# **Merwin Hydroelectric Project FERC Project No. P-935**

## **Application for License Amendment**

**APPLICATION FOR NON-CAPACITY AMENDMENT OF LICENSE  
FOR A MAJOR PROJECT – EXISTING DAM**

Subject: Criteria for Bull Trout Passage Facilities

**Figure 1. Lewis River Basin and major tributaries to Swift Reservoir.**

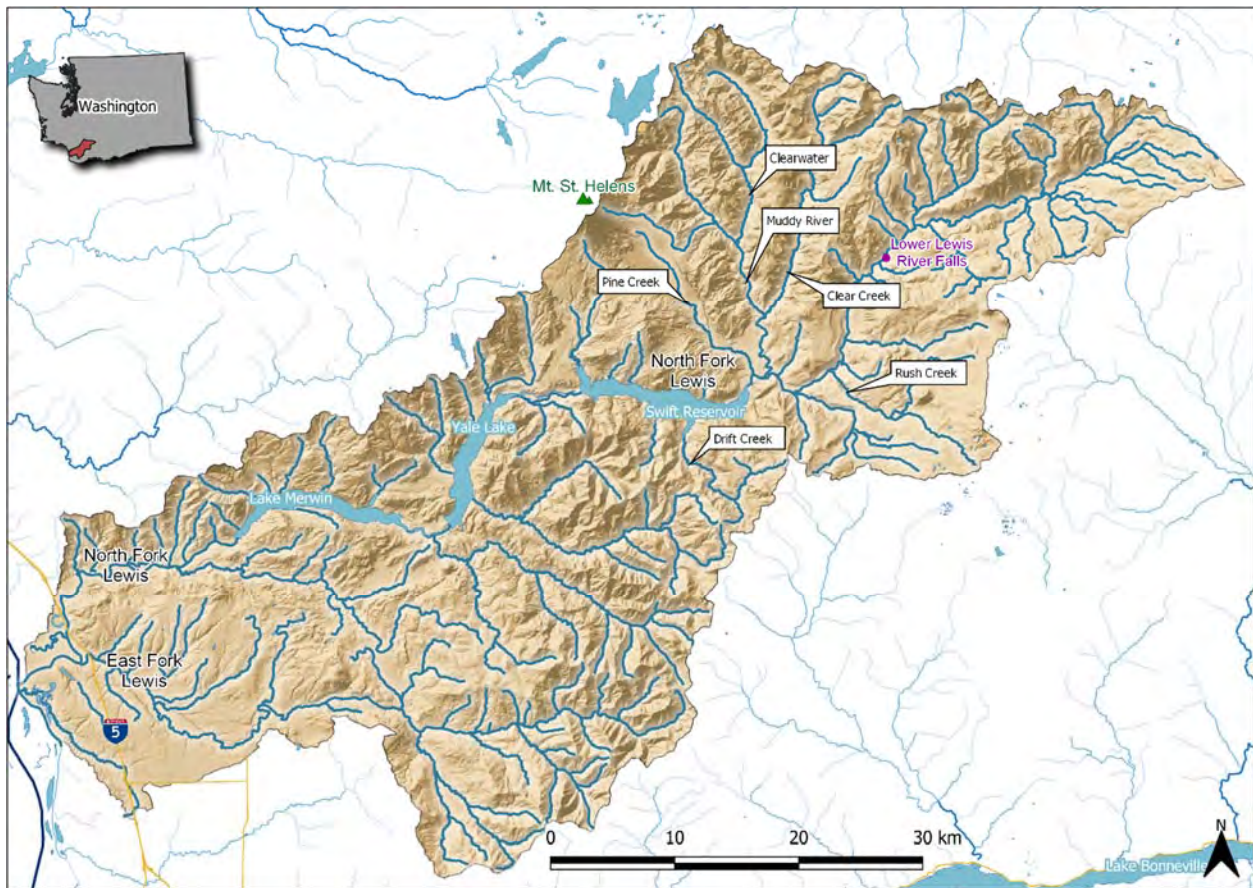
WDFW	11	Please include a legend in Figure 1. It is unclear if the red dots are the upper extent for fish passage or used to identify the stream/river.	Figure 1 of the Strategic Plan has been revised.
WDFW	12	The Strategic Plan identifies previous restoration work in the Lewis River watershed by sponsor. Please identify the location in the watershed the sponsors completed restoration activities. Since NMFS designated that restoration efforts focus on stream reaches above Swift reservoir, limiting the list to projects above Swift reservoir would be more appropriate.	To the extent possible, prior restoration projects completed in the upper watershed have been identified/summarized - sources of information include NOAA's PNW Salmon Habitat Project Tracking Database.
WDFW	13	It currently inappropriate to state “...it is the intent of the Utilities, Services, and Aquatic Coordination Committee (ACC) to develop a framework for an [Habitat Restoration Plan (HRP)] that will include reach and site-specific recommendations for restoration and enhancement measures.” WDFW believes that the Utilities have not confirmed with the ACC that it supports development of a framework for HRP or the content of the HRP.	Text has been revised as follows: "As described in Section 2.0 of this Plan, it is the intent of the Utilities and Services, <del>and Aquatic Coordination Committee (ACC)</del> to develop a framework for an HRP that will include reach and site-specific recommendations for restoration and enhancement measures."

- Please include a legend in Figure 1. It is unclear if the red dots are the upper extent for fish passage or used to identify the stream/river.
- The Strategic Plan identifies previous restoration work in the Lewis River watershed by sponsor. Please identify the location in the watershed the sponsors completed restoration activities. Since NMFS designated that restoration efforts focus on stream reaches above Swift reservoir, limiting the list to projects above Swift reservoir would be more appropriate.

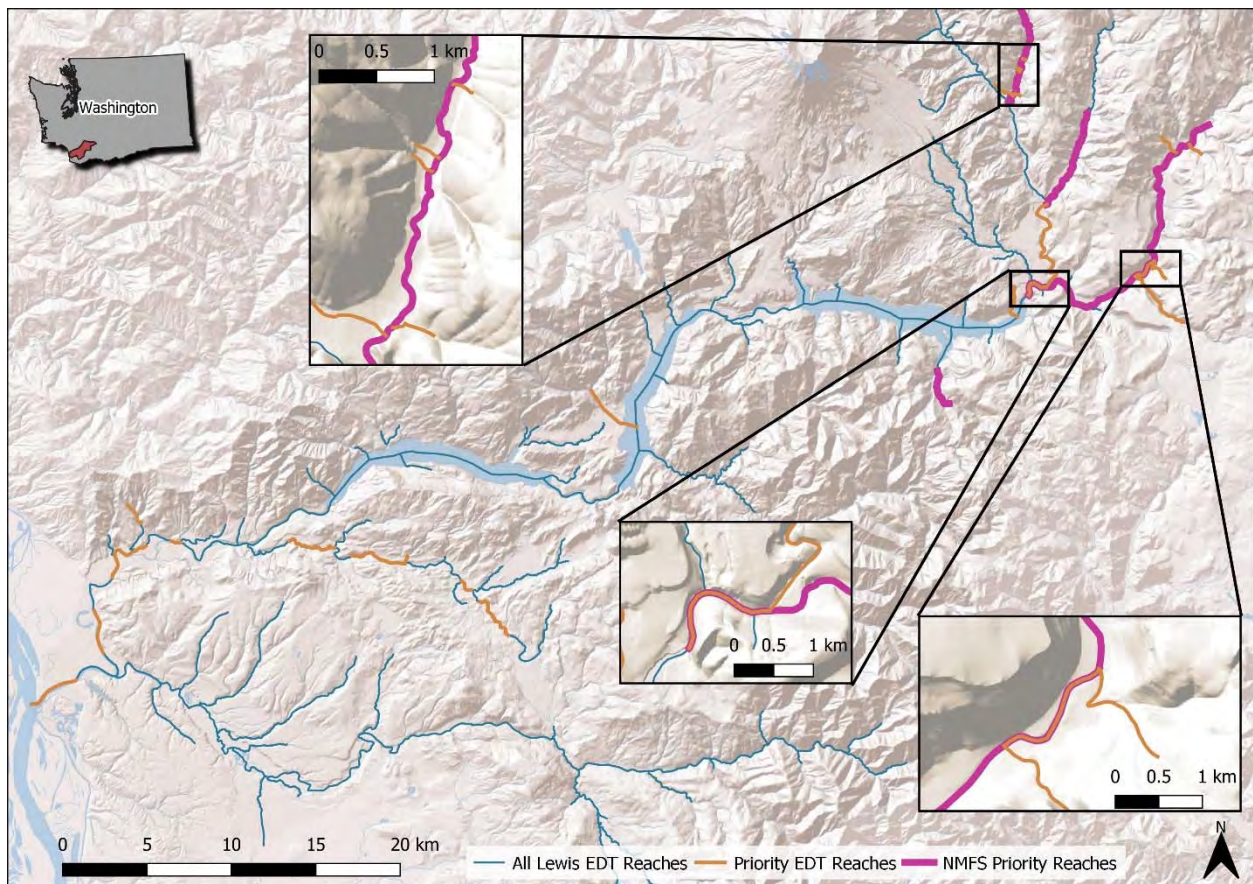
- Figure 4. and other sections within the Strategic Plan propose to prioritize protection and preservation above restoration of watershed processes and habitat features. This is contrary to the goals and objectives outlined in the In Lieu Letter and in Settlement Agreement section 7.6.3. Prioritizing protection and preservation projects before restoring habitat functions and features is not likely to meet the In Lieu Letter or Settlement Agreement goals/objectives. From WDFW’s perspective, not only should the ACC collectively determine the goals of the Merwin In Lieu Program and HRP, it should also collectively determine the prioritization of protection and preservation, restoring watershed processes, and restoring habitat features.
